SIS: Summary of changes

Jorg and Laurette

LHC SIS GUI

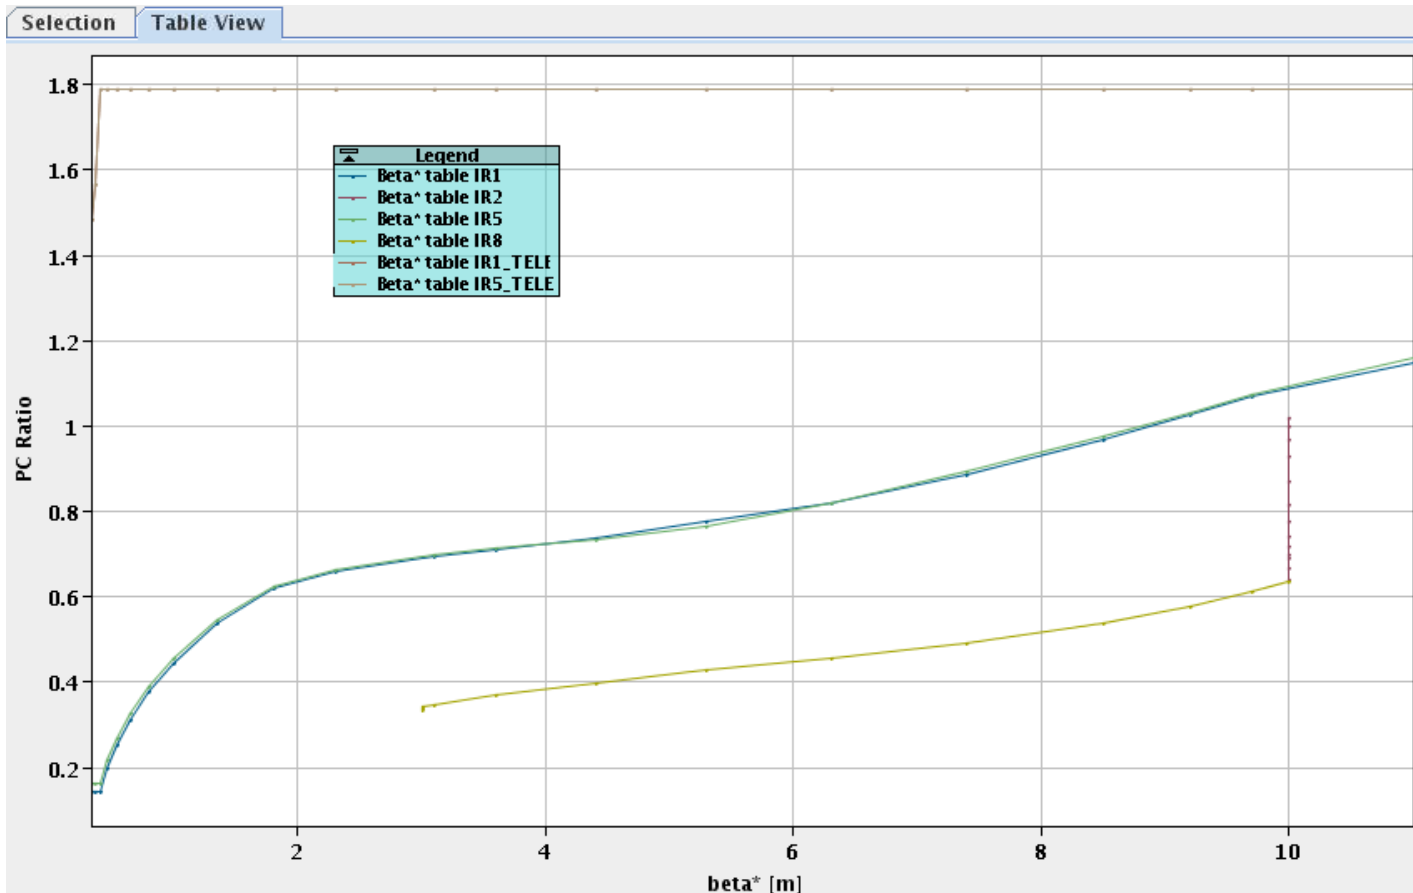
- ❑ Ring permit active in 2016:
 - *Simple check that values of gauge VGMA.6894700.B and VGMA.6294700.R are in range 1.1-1.35 bar*
 - *Proven to be reliable last year*
- ❑ New after YETS:
 - *New piezo gauge, old gauge changed names*
 - *Parameters OK, just need to agree on the logic*
- ❑ Recommendation from MPP:
 - *Beam dump if values < 1 bar (1 min temporization for bad readings + communication lost)*
 - *Combination of the 2 gauges or only new one?*
 - *Tempo is OK for loss of communication, not for bad readings*
 - more complex code needed
- ❑ For injection inhibit:
 - *Either of the 2 readings is < 1.025 bar OR readings diverge by ≥ 0.1 bar*
 - Again more complex logic to be implemented and tested

Recommendation for 2017 operation

- As before: XPOC injection inhibit
 - Update to new operational range
XPOC limit at 1.025 bar instead of previous 1.1 bar
 - Change to newly installed gauge at the dump volume

- SIS interlock:
 - New: Injection inhibit if either of the two pressure readings is < 1.025 bar OR if pressure readings diverge by ≥ 0.1 bar (temporization by 1 min, allowing for bad readings + communication loss)

- As before: Beam dump if pressure reading on piezo gauge on dump volume is < 1 bar (1min temporization for bad readings + communication loss)
- New: Hardware channel from newly installed piezo gauge connected for additional diagnostic (using 2 controllers and locally programmable thresholds)

- Warning/Alarm if pressure reading on piezo gauge on dump volume is < 1 bar
 - Following outcome of studies this channel might be consolidated for appropriate reliability (detailed via ECR) to become an active interlock channel (beam inhibit or dump)
